The NRC staff's review of Sam Miranda's 10 CFR §2.206 petition of November 15, 2016:

The PRB has not performed the thorough, unbiased evaluation that is necessary to close its review. The PRB's evaluation [1] of my 10 CFR §2.206 petition [2] fails for the following reasons:

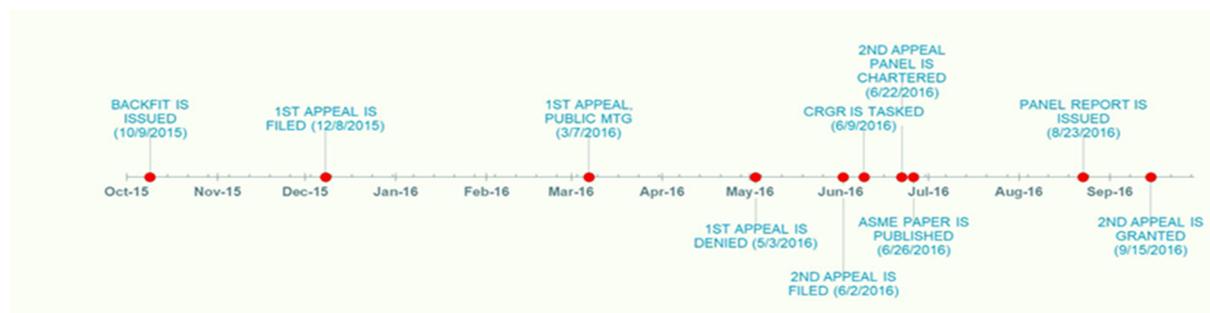
The BARP's purpose is stated on page 2 of its report [5]. It is to, *provide information and recommendations to support the EDO's decision on the appeal*. So, the BARP is not really a review panel. It's more of a Backfit Approval & Reversal Panel. This can be seen in the following timeline of events [17].

Note that it took the NRR appeal panel almost five months to consider, and ultimately deny Exelon's first appeal. It took the EDO only one week to issue a tasking memorandum, to the CRGR, to review the *lessons learned* from the backfit appeal, and develop a plan to apply them. Two weeks later, the EDO chartered an appeal panel of five (i.e., the BARP) to *provide information and recommendations* [5] to support his decision to grant Exelon's second appeal. One of the BARP's five panel members is also the chairman of the CRGR. The NRC did nothing to resolve the conflict of interest, even after an objection from the petitioner.

Two months later, the BARP issued its report [5]. It applied its *well-informed staff engineering judgment*, to conclude that the PSVs need not be assumed to fail, after having discharged water. Meanwhile, a technical paper was published by the ASME that dealt with some of the same issues the BARP was considering [15]. This paper reached a different conclusion.

The timeline also shows that the NRR appeal panel, which was considering Exelon's first appeal, held a public meeting on March 7, 2016. The BARP completed its review without convening a public meeting.

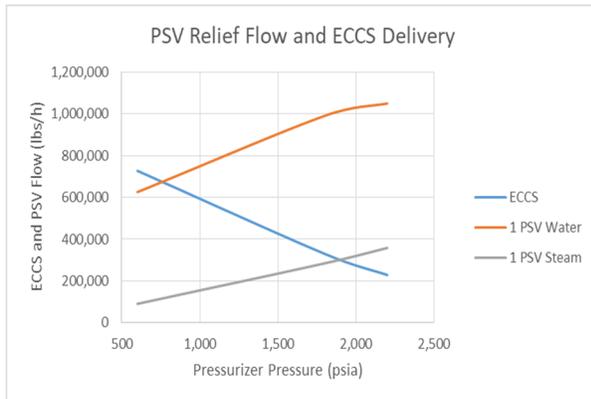
The following figure, copied from [2], shows that the water relief rate through one open PSV will be greater than one million lbs/h. The same curve could also be interpreted as representing the water leak rate through the three seated PSVs. The curve is based upon the calculated relief rate for saturated water. The calculated relief rate for subcooled water would be much higher. If the minimum expected discharge water temperature is as low as 590 °F, as claimed by Exelon [7], then the calculated water relief, or leak rate would be greater than 1.7 million lbs/h.

A leak rate that exceeds the ability of the normal makeup systems to replace the lost water is defined as a LOCA. So, an IOECCS that occurs in the Byron and Braidwood plants will result in a LOCA, even if all the PSVs reseal, after having relieved water. Furthermore, Exelon does not explain how an unisolable leak rate that exceeds one million lbs/h could be deemed to be an acceptable outcome for an AOO, and the NRC staff doesn't ask.

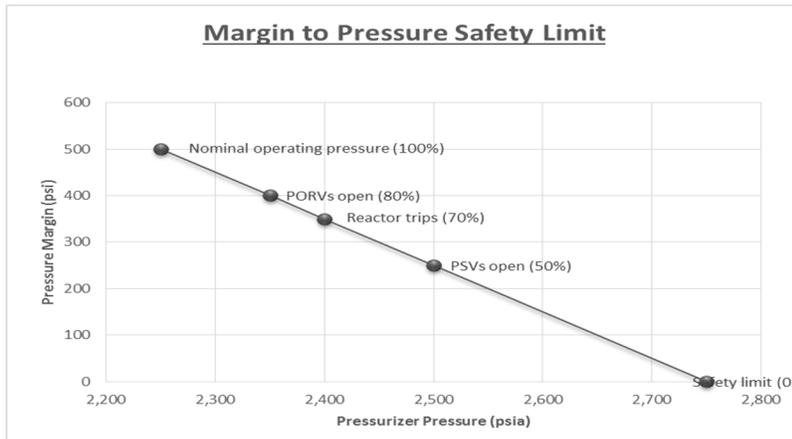
When the PORVs are applied, the margin of safety, to RCS overpressure is 400 psi (2750 psi minus 2350 psi). When the PSVs are applied, the margin of safety, to RCS overpressure is reduced to 250 psi (2750 psi minus 2500 psi). The margin of safety is thus reduced by 37.5%. For perspective, 150 psi is more than half the pressure that is developed inside the boiler of a steam locomotive. Note that the question has nothing to do with the valves' performance under steam or water relief conditions.

Exelon's plan to use PSVs, in lieu of PORVs, significantly reduces pressure safety margin, as depicted in the following figure.
